BROKEN ARROW PLANNING COMMISSION AND CITY COUNCIL

PT22-106 Preliminary Plat Checklist

[1] 51 west - base-PLAT (24)

51 WEST
Sheet 1 of 3

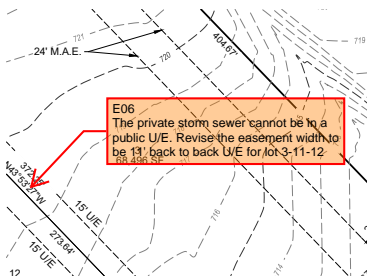
E05
The city does not have a waterline along highway 51, there is a waterline shown on the utility plan but the owner is not identified. If RWD will be supplying water to the site then the easement for the waterline will need to be specified as an RWD easement separate from the city easements. The RWD4 contact will need to be added to the contact list.

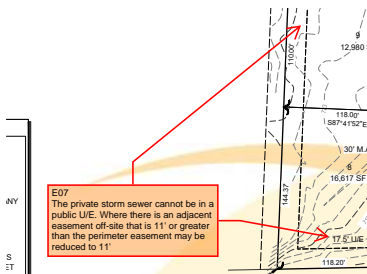
E06
The private storm sewer cannot be in a public U/E. Revise the easement width to be 13' back to back U/E for lot 3-11-12

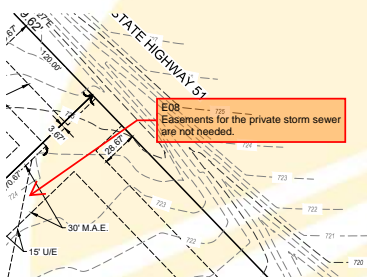
E07
The private storm sewer cannot be in a public U/E. Where there is an adjacent easement off-site that is 11' or greater than the perimeter easement may be reduced to 11'

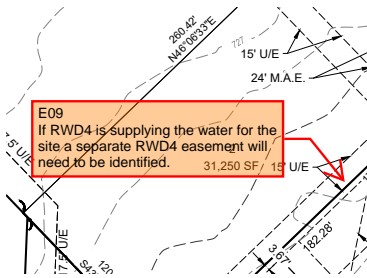
E08
Easements for the private storm sewer are not needed.

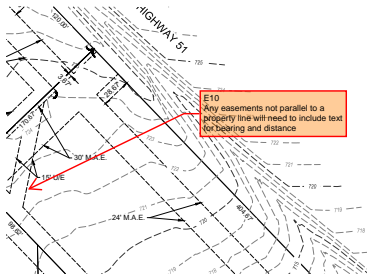
E09
If RWD4 is supplying the water for the site a separate RWD4 easement will need to be identified.

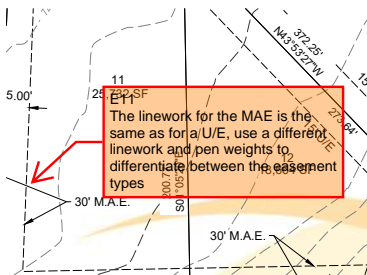
E10
Any easements not parallel to a property line will need to include text for bearing and distance

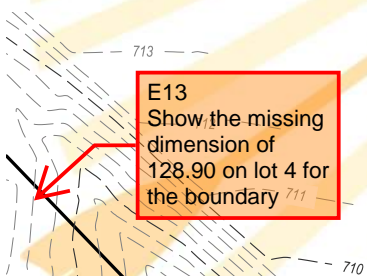
E12
The Tanner pin is not referenced for anything and there is only an assumed bearing from the reserve.
Why is this being shown?

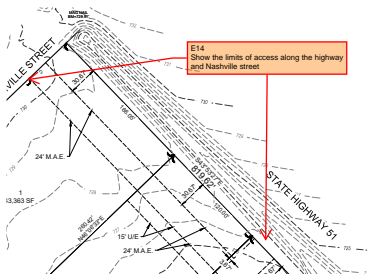
E13
Show the missing dimension of
128.90 on lot 4 for the boundary

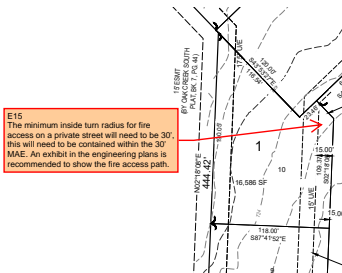
E14
Show the limits of access along the highway and Nashville street

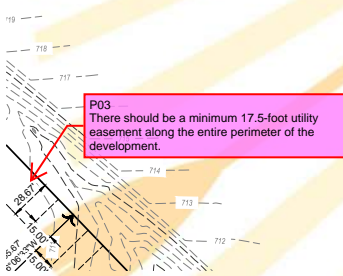
P02
Show the total right-of-way for Highway 51. Proposed driveway locations must be shown in accordance with the zoning ordinance.

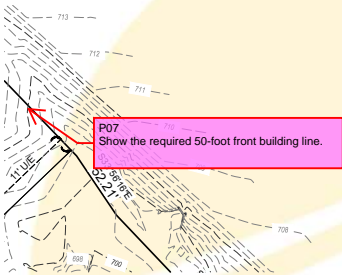
P06
Per PUD-336, Development Area B (Lots 8, 9, & 10) is to be developed by the standards of the ON zoning district. Show 50-foot building setbacks on all street facing lots.

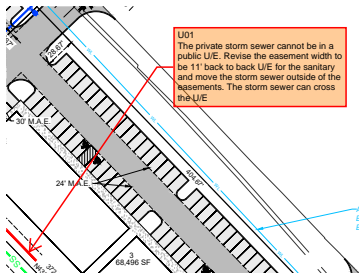
P12
Correct lettering.
